IRC - Building

2022 GROUP B PUBLIC COMMENT AGENDA

2022 Public Comment Agenda

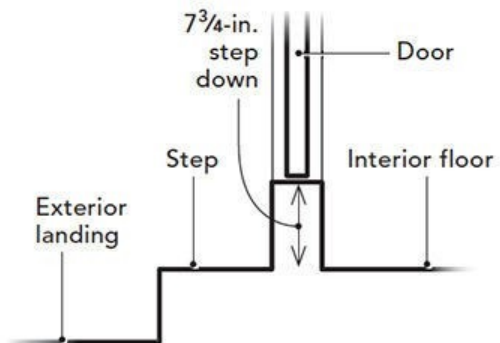
Reason: This proposal started as question – Can the landing or steps into a garage be the same as permitted for exterior doors or not?

The following are current requirements - There is a requirement for landings at exterior doors (R311.3) and a requirement for landings at the top and bottom of stairways (R311.7.6). The required egress door has to open directly into a public way, yard or court (R311.1), so it has to be an exterior door. Egress is not permitted through a garage (R311.1).

Interior doors not have requirements for landings, so going out to a single step or multiple steps would be covered by the stairway landing requirement in Section R311.7.6. The current exception clarifies that steps into a garage are considered interior stairways.

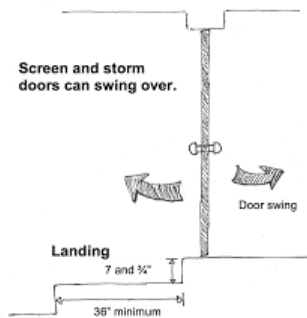
This is what is permitted with current text for exterior doors other than the means of egress doorway. While perhaps there should be a threshold limit (not proposed here), the current allowances is a serious tripping hazard.

Was this not the intended allowance?

R311.3.2 – This is a requirement for a landing or floor at both sides of an exterior doorway. This section has 'exterior' in the title, and is a subsection of 'exterior doors', but does not have 'exterior' in the text. Since titles are not part of the text, this could be read as all door, or it could be read to allow a 7-3/4" drop between the floor and the threshold on both sides of the door. The modification to the body of the text would limit this to exterior doors and the exterior side for the step down. The current exception is for a stairway landing, not a door landing, so this needs to be more specific

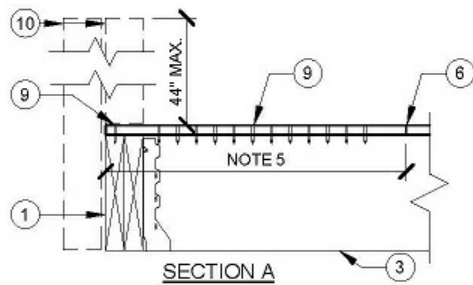
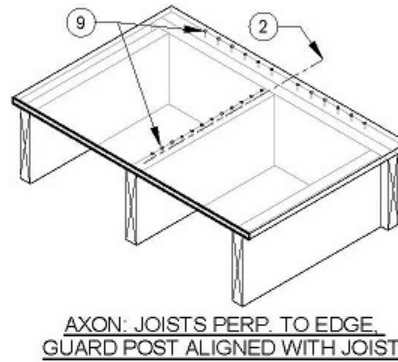
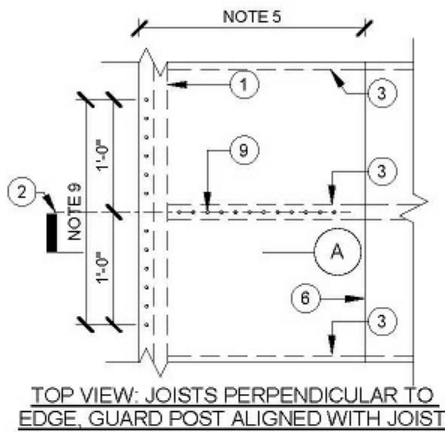
Commenter's Reason: The Committee approved this proposal because it provides a prescriptive solution for floor framing supporting guards that will resist required design loads applied to the top of the guard and ***corrects a serious deficit*** in the current requirements for floor framing ***that void the warranties of engineered floor systems and allows the potential failure of the floor and connected guard assembly/system.*** However the Committee specifically requested clarification by public comment. The changes included in this modification are described below. They address not only the Committee's request but also those issues raised in testimony, further collaboration of industry and editorial changes to aid in understanding.

3. Questions from the committee and testimony inquired as to the difference between the application of R502.11.1 and R502.11.2. The purposeful application of each section has been clarified by moving the text related to the *alignment of roll bracing with the guard posts* to the beginning of both sections to clearly establish and differentiate the dependent condition for use of each section.

4. Some of the Committee members questioned that it was not clear that R502.11.1 does not preclude the use of Structural Composite Lumber. To clarify this the phrase "*...member of lumber, structural glued laminated timber, or structural composite lumber*" has been substituted for "*wood*" to specifically include these options. Structural composite lumber would include: LVL, PSL, LSL, or OSL. The drawings included for the commentary have also been clarified.

R502.11.2 Timber edge framing. ~~Where a roll brace is not aligned with each guard post, the~~ The framing at the edge of the floor shall consist of a minimum 6x10 sawn timber or a minimum 5-1/8 inch x 9-1/4 inch (130 mm x 235 mm) structural glued laminated timber and shall be braced to resist rotation by roll bracing as described in Section R502.11.3 at intervals of 48 inches (1219 mm) or less.

R502.11.3 Roll bracing. Each roll brace shall be a joist or blocking matching the depth of the edge member and extending perpendicular to the edge member a minimum of 16 inches (406 mm) from the edge. Blocking shall have end connections with a minimum of six (6) – 16d common nails. Floor sheathing shall be continuous for a minimum of 24 inches (610 mm) from the edge and shall be fastened to each roll brace with a minimum of twelve (12) – 10d common nails and shall be fastened to the edge member with a minimum of twelve (12) – 10d common nails within 12 inches (305 mm) of the roll brace.

Figure R502.11.6(1)

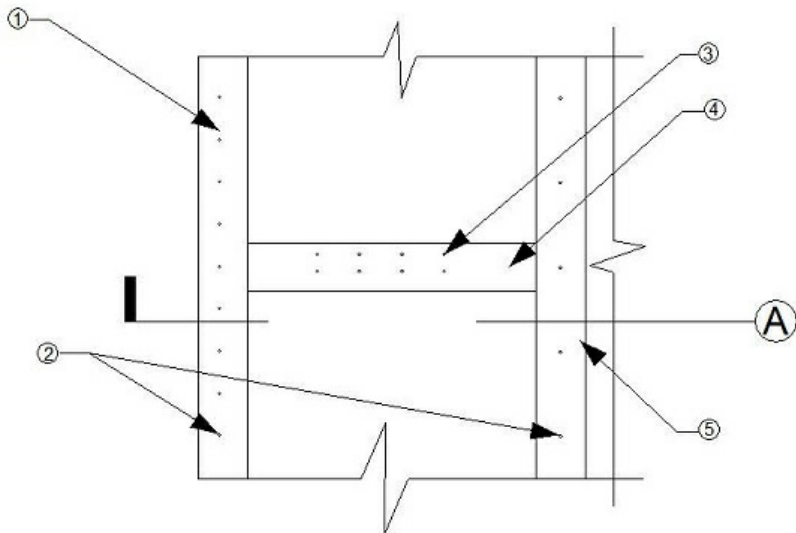
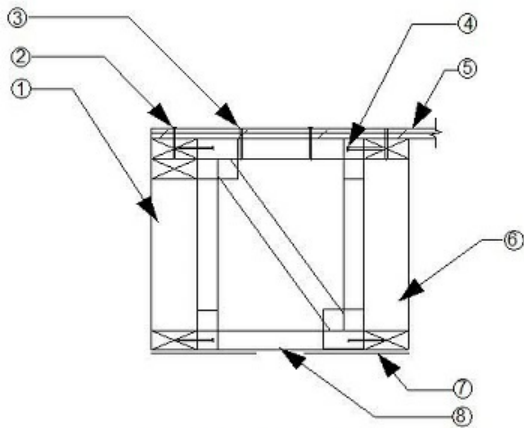
Commenter's Reason: The proponents of these comments agree that there is a need for adequate guard post connection. We have added a prescriptive method to include open webbed metal plate connected wood trusses to stair opening edge framing.

corner on each face with one 16d common nail, toe nailed. The bottom of the roll brace shall be connected to the bottom of the edge and common truss with a 3.125-inch x 7-inch (76 mm x 179 mm) 20-gauge steel strap with six (6) 8d nails (1.5inch x 0.131 inch) in each member in accordance with Figure R502.11.6(2) or R502.11.6(6) or 3.125 inch x 9 inch (76 mm x 229 mm) 20-gauge steel strap with six (6) 8d nails (1.5inch x 0.131 inch) in each member in accordance with Figure R502.11.6(4). When a side mount post connection is required the roll brace shall be connected to edge truss with a 3.125-inch x 5-inch (76 mm x 127 mm) 20-gauge steel strap with five (5) 8d nails (1.5inch x 0.131 inch) in each member in accordance with Figure R502.11.6(6). Floor sheathing shall be continuous for a minimum of 24 inches (610 mm) from the edge truss and shall be fastened to the edge truss with 8d common nails at 3 inches (76 mm) on center along the length of the floor opening, and to each roll brace with eight (8) – 8d common nails, four (4) nails in two rows. Floor sheathing shall be nailed to the common truss with 8d common nails at 3 inches (76 mm) o.c. within 24 inches of each guard post, and 6 inches (152 mm) o.c. o.c. for the balance of the span. Floor sheathing connection in accordance with Figure R502.11.6(1), Figure R502.11.6(3) or Figure R502.11.6(5).
